Work Order ID 107383

Item Name: Aft Crosstube - Low Standard

DART AEROSPACE LTD		Work Order:	107383
Description: Crosstube Low Aft (205/212)		Part Number:	D212-664-207
Inspection Dwg: D212-664-247 Rev: B		Page 1 of 1

DRAWING NO. D212-664-247	TITLE CROSSTUBE ASS'Y (205 LOW AFT)	REV. B	DART AEROSPACE LTD ENGINEERING ORDER	D.E.O. NO. D212-664-247-B-1	SHEET NO. SHEET 1 OF 1	SCALE NTS
DRAWN <i>q</i>	CHECKED <i>ASS</i>	MFG. APPR. <i>AB</i>	APPROVED <i>WD</i>	DE APPR. <i>AB</i>		
DATE 11.07.15	DATE 11.07.20	DATE 11.07.21	DATE 11/07/21	DATE 11.07.21

**D212-664-247/-247B
ASSEMBLY DETAIL** △ B

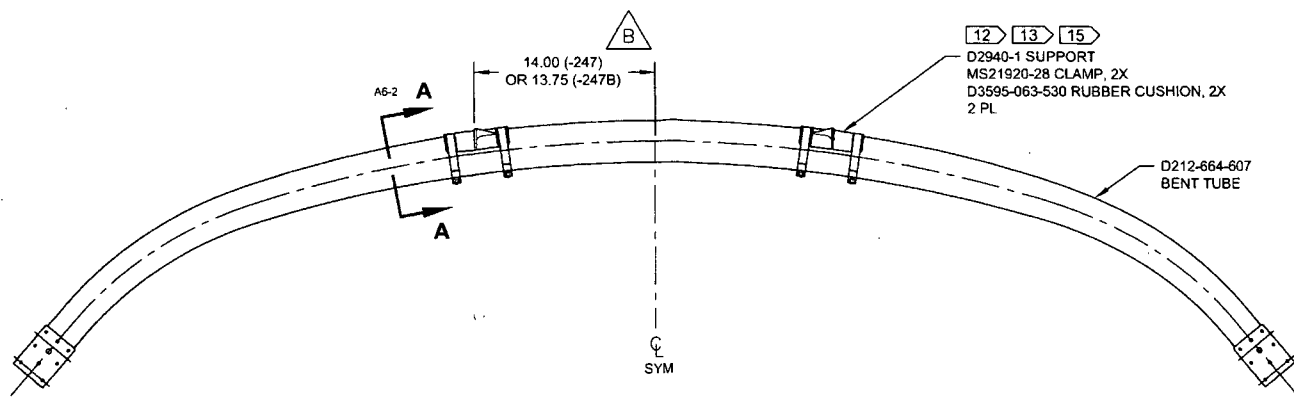
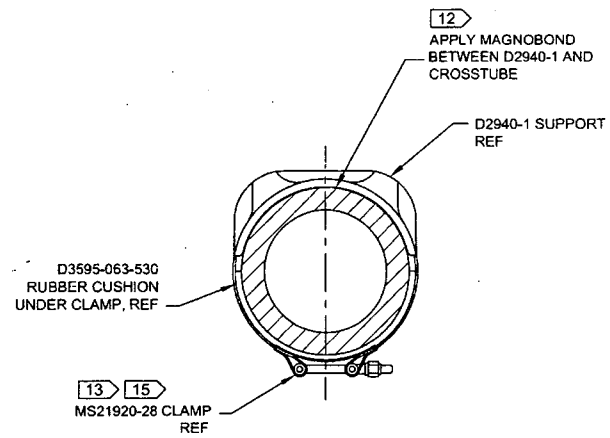
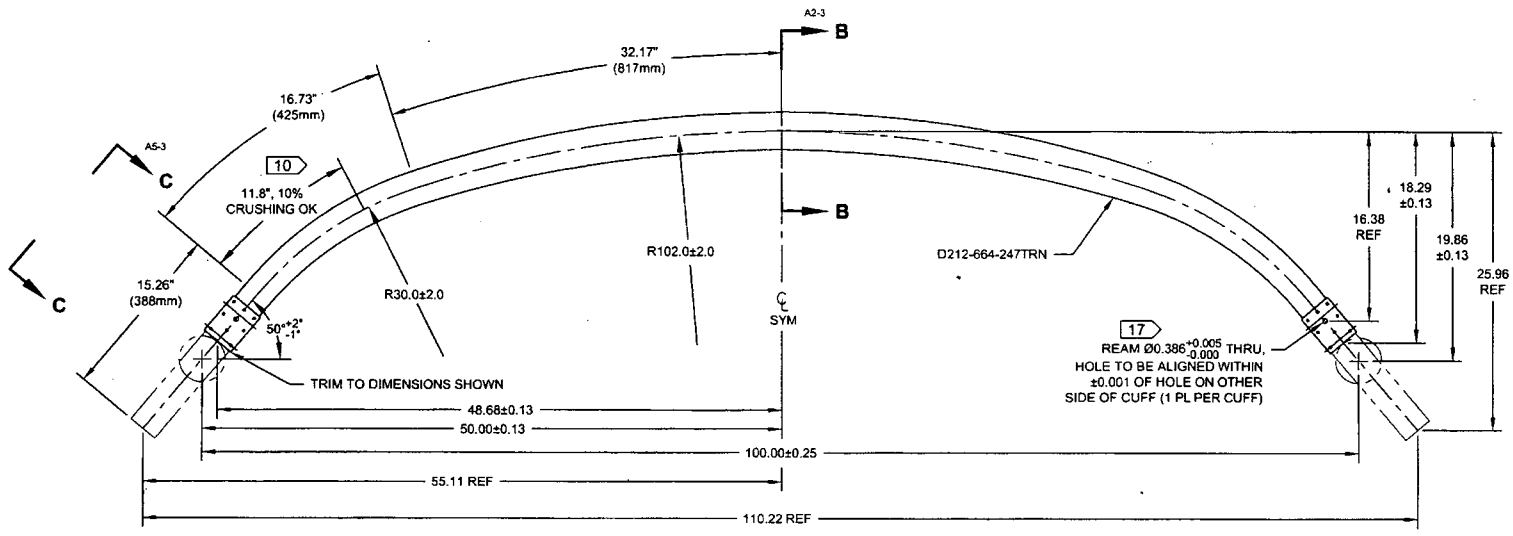
REPLACE MAGNOBOND WITH PROSEAL

NOTE 12 & 15, SHEET 1 IS AMENDED AS FOLLOWS:

- 12) TO INSTALL D2940-1 SUPPORT: ABRABE MATING SURFACE OF SUPPORT AND CROSSTUBE WITH 180-GRIT SANDPAPER AND REMOVE RESIDUE WITH MEK (OR EQUIVALENT). APPLY A 0.04" TO 0.07" THICK LAYER OF PROSEAL 890 CLASS B-2 (OR AMS-S-8802 CLASS B-2) SEALANT TO MATING SURFACE OF SUPPORT.
- 15) TORQUE CLAMPS 80 TO 100 IN-LB. ENSURE AT LEAST 1.5 THREADS SHOWING IN SAFETY AND THAT NUT HAS NOT BOTTOMED-OUT AFTER TORQUING. PRIOR TO PACKAGING, RE-CHECK TORQUE ON CLAMPS AFTER PROSEAL 890 SEALANT HAS CURED FOR 72 HOURS.
